South Texas Project Electric Generating Station P.O. Box 289 Wadsworth, Texas 77483

August 19, 2010
U7-C-STP-NRC-100193

South Texas Project
Units 3 and 4
Docket Nos. 52-012 and 52-013
Revised Response to Request for Additional Information

RAI 03.08.04-18, Revision 1, Supplement 1**QUESTION:****Follow-up to Question 03.08.04-2 (RAI 2964)**

FIGURE 12.3-38 RADWASTE BUILDING, RADIATION ZONE MAP, NORMAL OPERATION AT ELEVATION 5300 MM

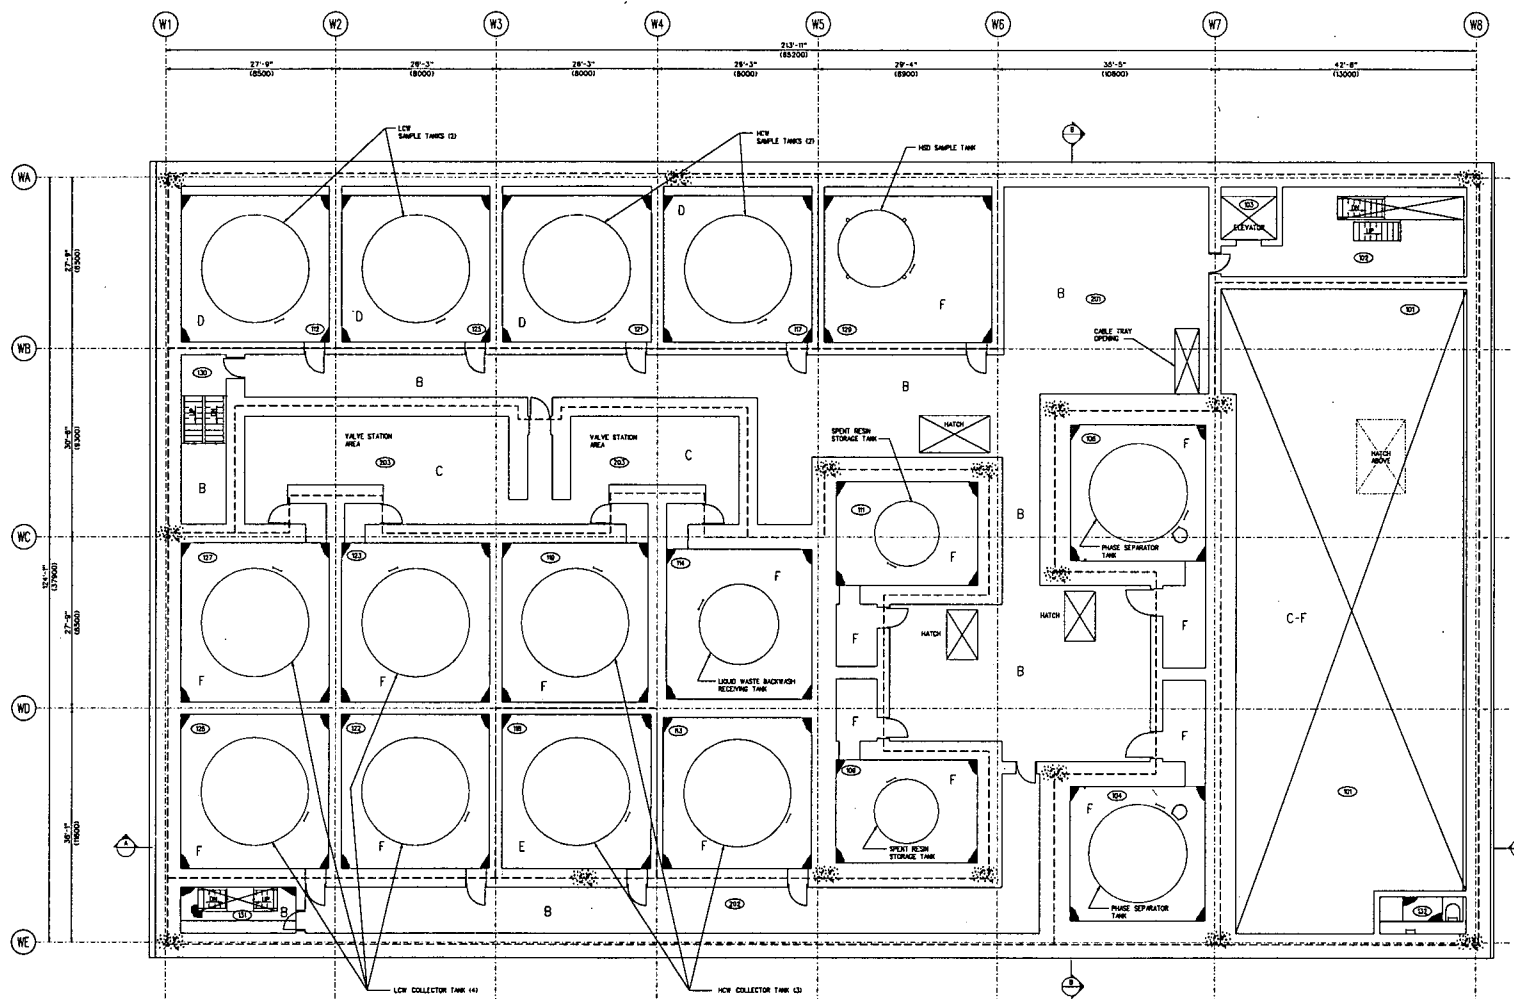
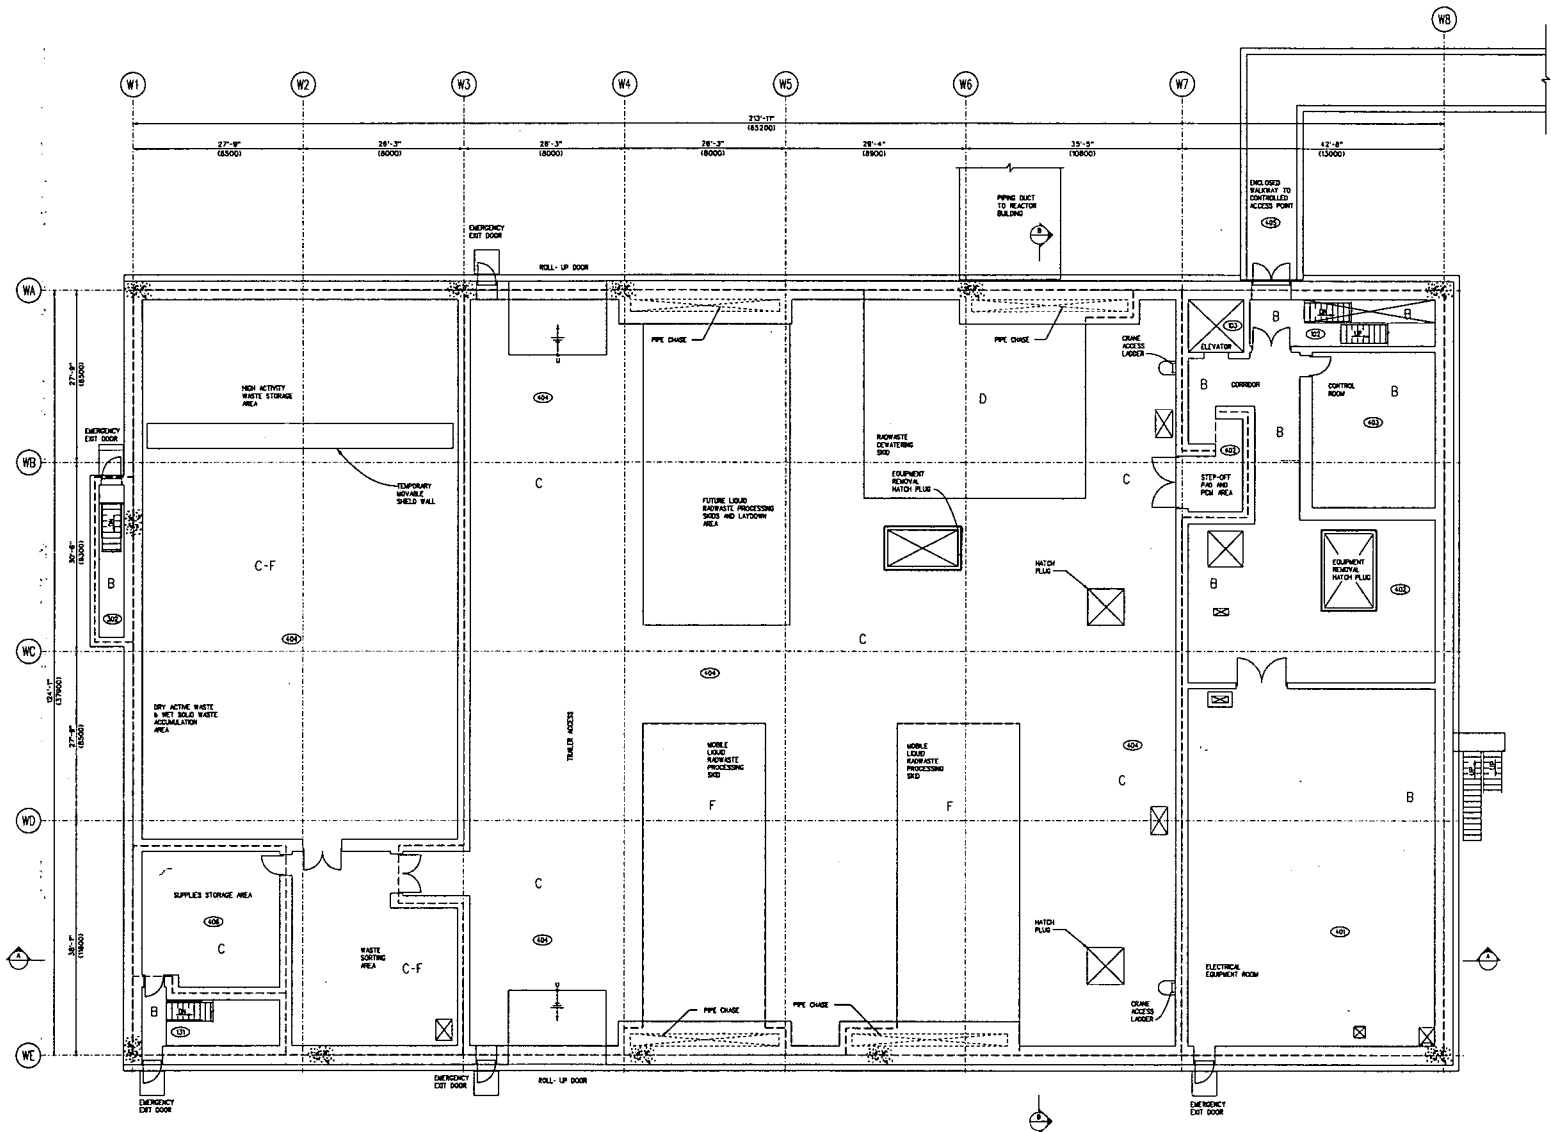
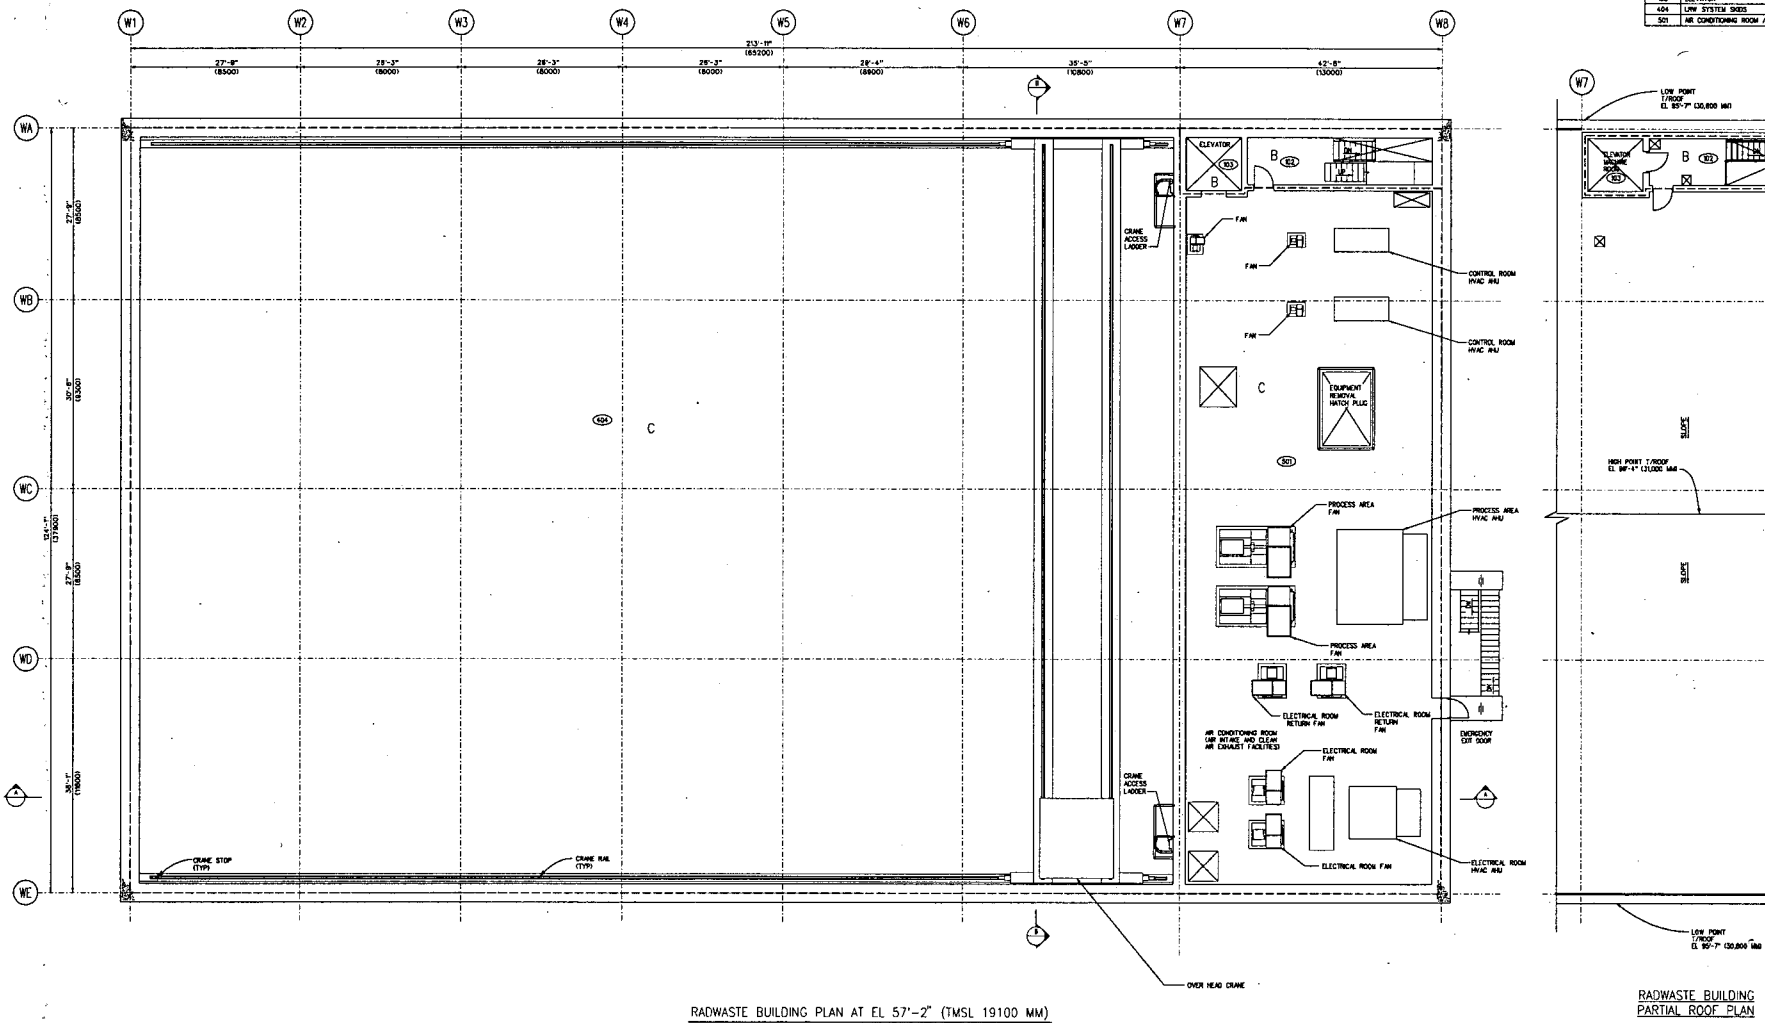
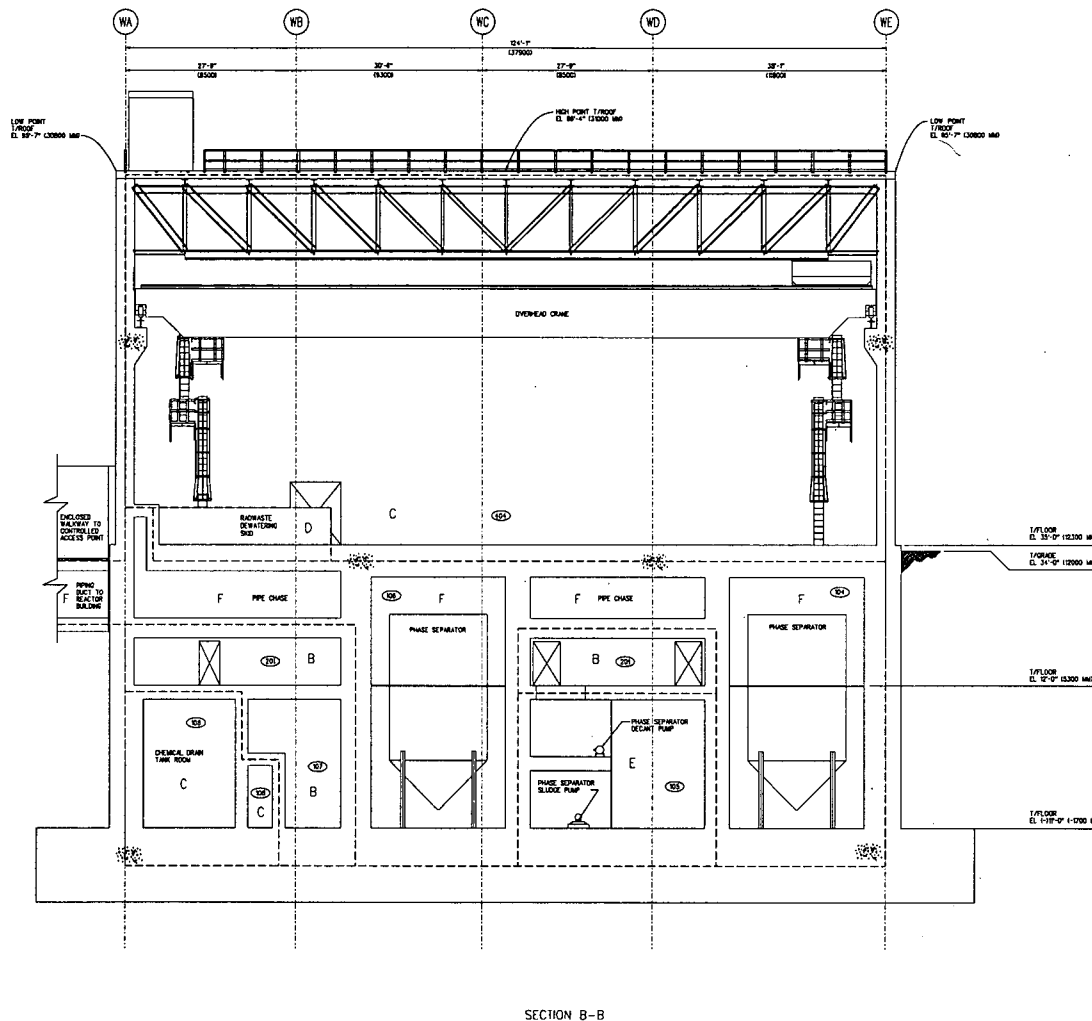
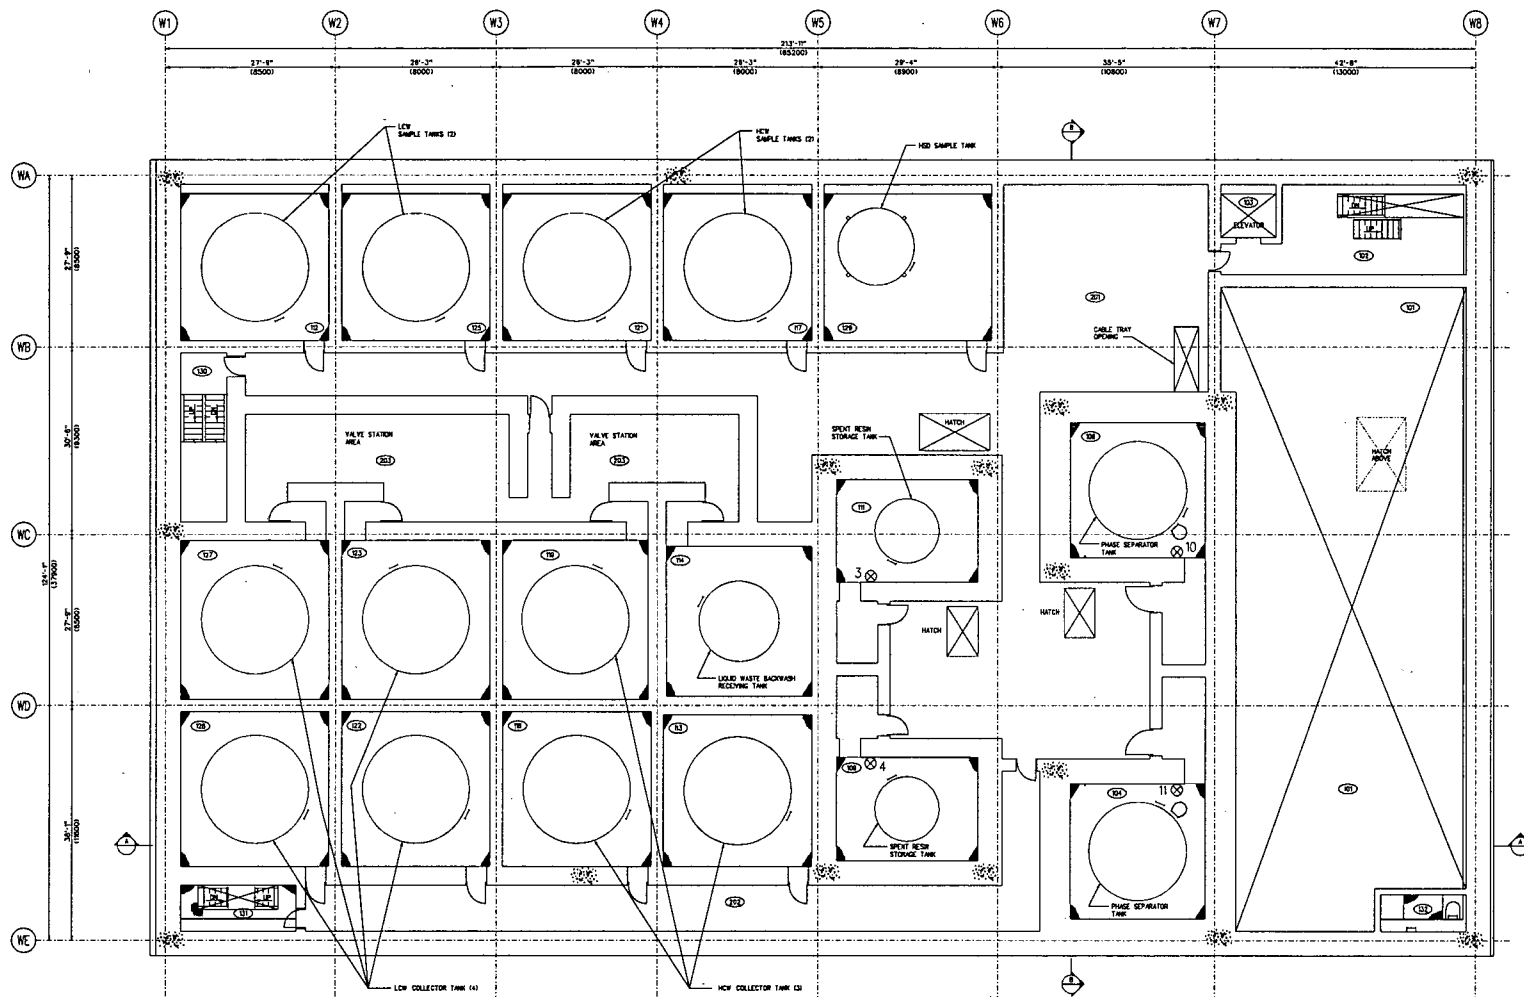
Radiation Zone Maps (Figures 12.3-37 through 12.3-41)

The changes in the arrangement shown on the RWB GAs do not result in any changes to the radiation zone designations for the various areas (equipment rooms, pipe chases, hallways, etc) in the RWB. The radiation sources in the individual rooms remain the same (i.e., the room and the source in it are moved), and the shielding is adjusted as necessary to ensure the radiation levels in protected areas correspond to the established radiation zone (the shield wall thickness changes are associated with situations where the area outside of the room has a different radiation zone). The changes in the shielding wall thicknesses are described in the markup of FSAR Table 12.2-5c (see below).

FIGURE 12.3-66 RADWASTE BUILDING, AREA RADIATION MONITORS AT ELEVATION 5300 MM

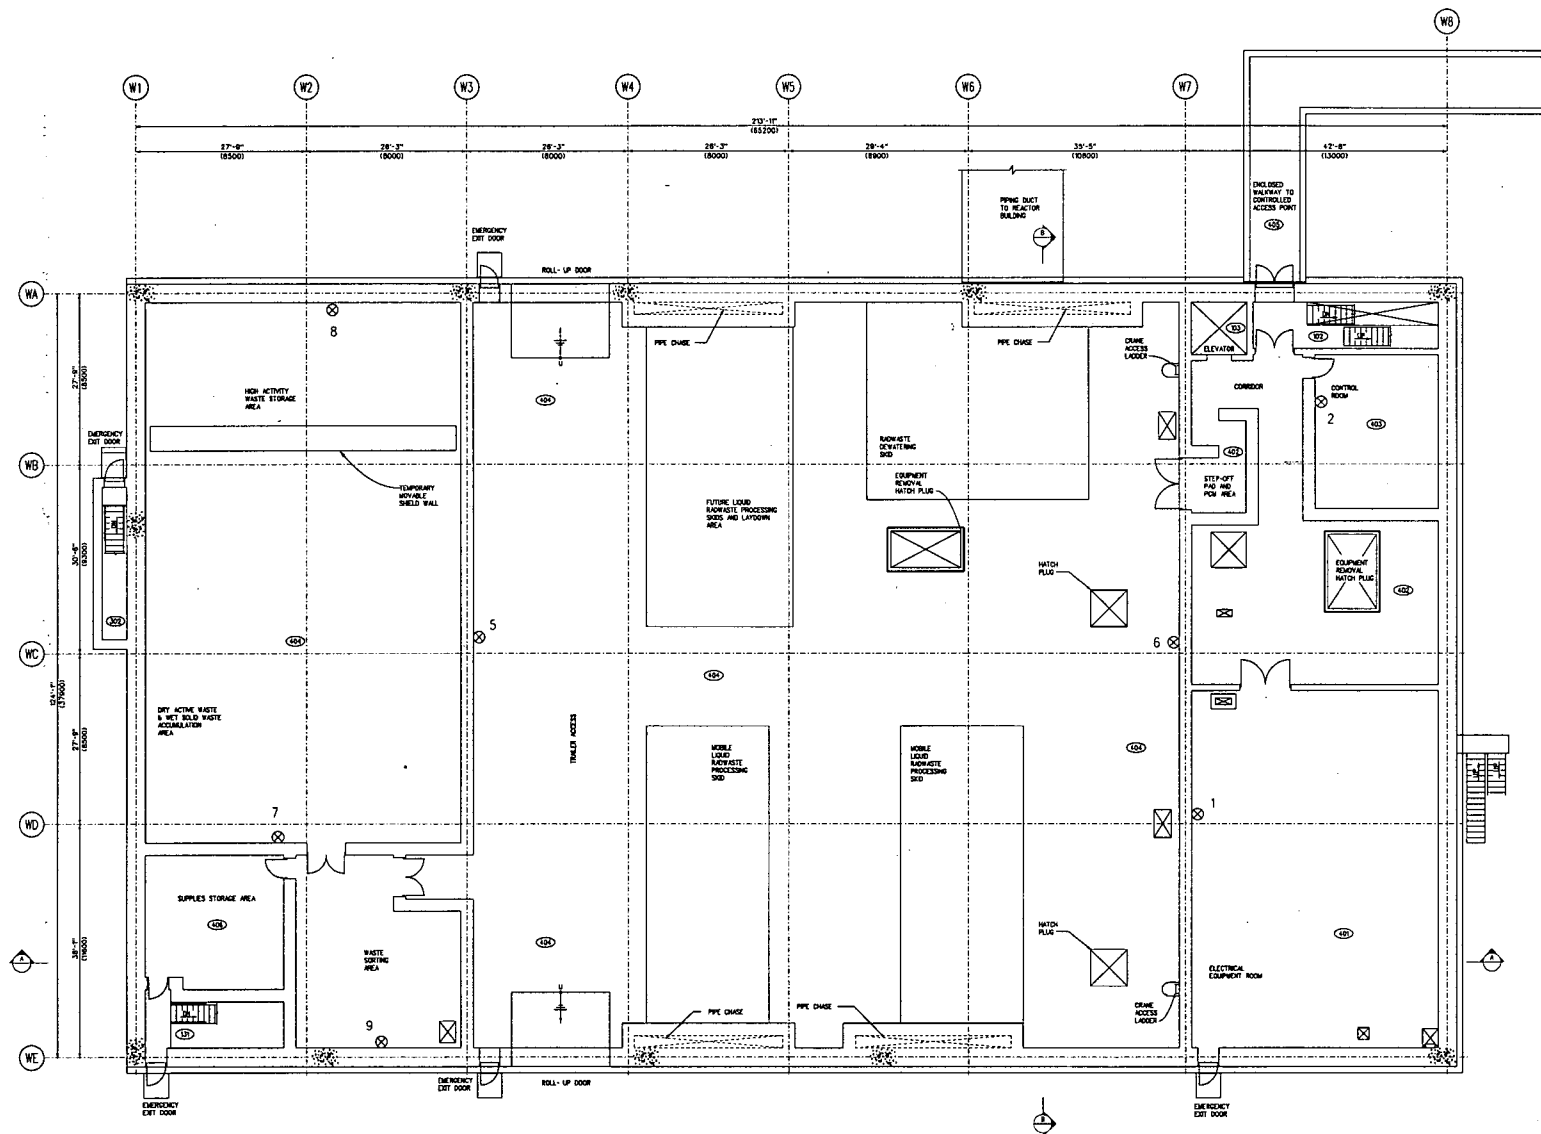
Figure 12.3-66

- The Electrical Equipment Room radiation monitor (No. 1) is removed from this figure, and is now shown on Figure 12.3-67 because the room was moved to that elevation. It serves the same function.
- The phase separator tank room monitors (No. 10 and 11) were moved from the west end of the RWB to near the east end because the phase separator tank rooms were moved. The radiation monitors are still located inside the phase separator tank rooms. They are relocated with the tanks and serve the same function,
- The spent resin tank room monitors (No. 3 and 4) were moved west one column row because the spent resin tank rooms were moved. The radiation monitors are still located inside the spent resin tank rooms. They are relocated with the tanks and serve the same function.

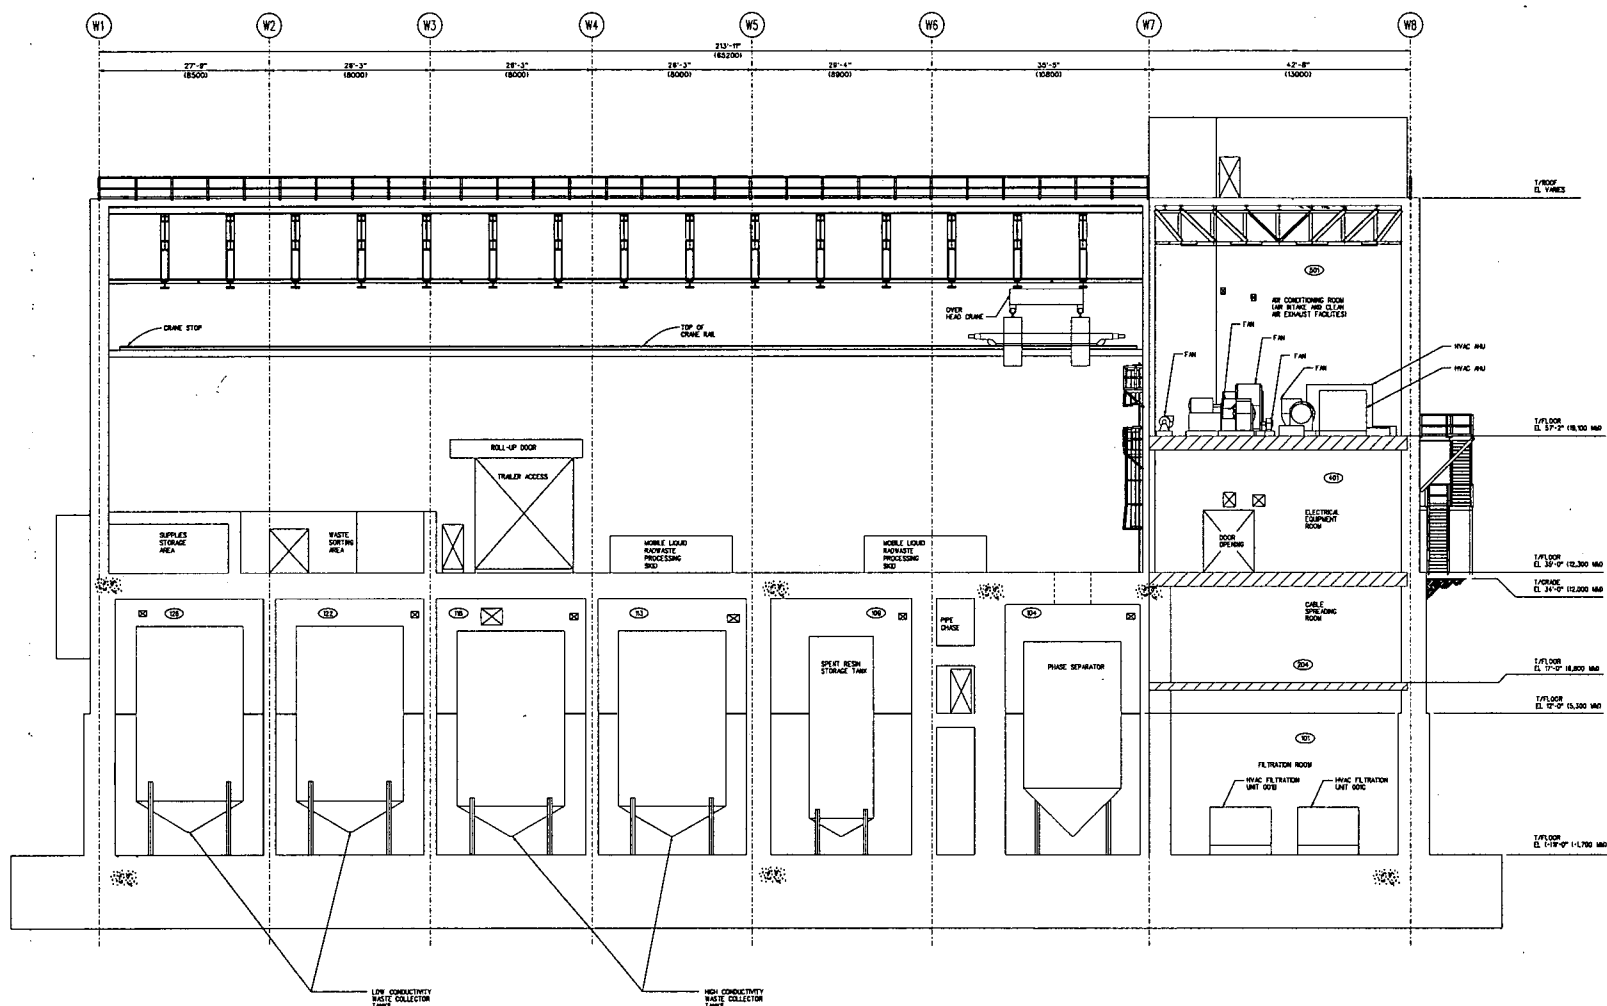
Figure 12.3-67

- The Electrical Equipment Room radiation monitor (No. 1) is added to this figure because the room was moved to this elevation. It was previously shown on Figure 12.3-66. This location is comparable to previous location and the function is the same.
